Pre-lodgement Meeting Notes

Application No: PLM2024/0070

Property Address: 9 North Avalon Road AVALON BEACH

Proposal: Development Application Pre-lodgement Meeting

Development Application No. 0060/98 at 9 North Avalon Road, Avalon for alterations and additions and to increase the number of childcare places from 31 to 39 at "Bear 'n' Joey" childcare centre.

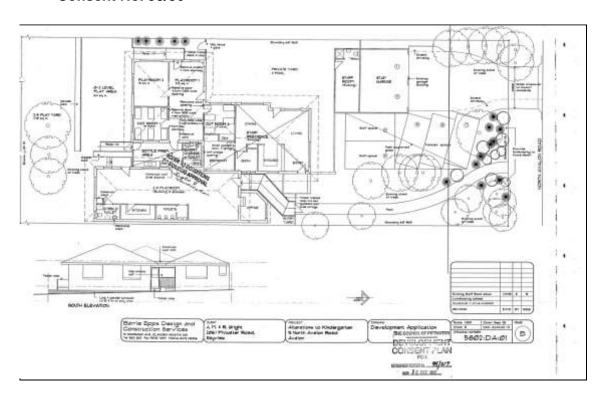
- Development consent was grated on 20 December 1995 for alterations and additions to the existing Kindergarten for a maximum of 31 children. This consent included the provision of 7 off-street car parking spaces (as per the approved plan 5801:DA:01 below) and driveway widening.

- Development consent was granted on 21 February 1997 for internal alterations and additions to the Day Care Centre and attached dwelling.
- Development consent was granted on 5 August 1998 for alterations and additions to increase the number of childcare places from 31 to a maximum of 39 children. The approval included the provision of 9 car parking spaces on site (being 2 extra spaces in front of the garage).

There were a number of conditions to ensure the carparking remained in place and was appropriately marked / retained for use. Additionally, the age groups for the childcare centre were limited to: 10 children 0-2 years, 16 children 2-3 years and 13 children 3-5 years.
